### 30S-1 RF LINEAR AMPLIFIER

#### SERVICE BULLETIN NO 2

#### PREVENT INTERMITTENT DROPOUT OF PLATE OVERLOAD RELAY

**30S-1 Relay Shelf, Underside, Modification Instructions**

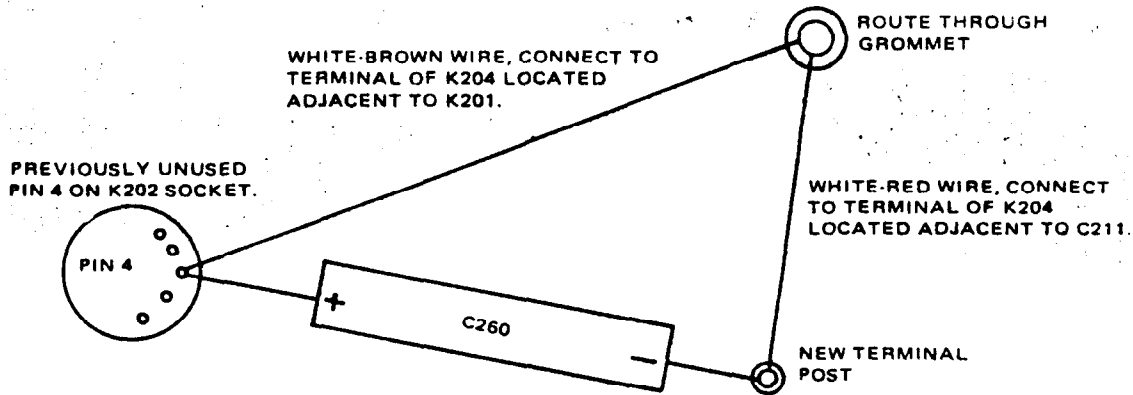
Some 30S-1 operators experience occasional dropout of plate overload relay K204, caused by short duration high plate currents. These currents sometimes occur after application of signal but before the exciter output is reduced by the alc circuits. A 2000- $\mu$ F, 6-volt dc capacitor installed across the energizing coil of the relay presents a low-impedance path to the audio envelope currents, but continues to provide dc overload protection. The instantaneous currents are not harmful to the 6CX1000A tube because of conservative tube operation.

To determine if this modification is installed, check for the presence of the tubular electrolytic capacitor visible at the left front underside of the relay shelf.

1. Remove all power to unit and remove relay shelf and position it in a manner to gain access to lower side of shelf. Locate K202 socket and K204 mounting nut on the underside of the relay shelf, and remove mounting nut.
2. Install terminal post (306-0978-000) in place of removed K204 mounting nut.

3. Install 2000- $\mu$ F capacitor C260 (183-1311-000) and approximate 10-inch lengths of white-brown (439-7302-000) and white-red (439-7303-000) wires as shown in the illustration.
